FROM: Mitesh Baxi
Traffic Engineering

■ **COURTYARD AT MIDTOWN VILLAGE [TRC Plan Review #2]**

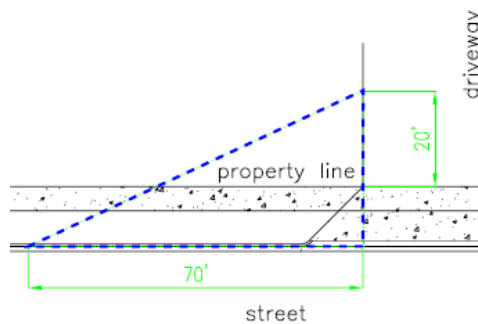
1. The sight distance triangles are not implemented as per City standards. The City's 20'x70' and 46'x46' sight distance triangle shall be measured as per the image below. [\[Sec.18-529\(c\)\(3\)CofW LDC\]](#)
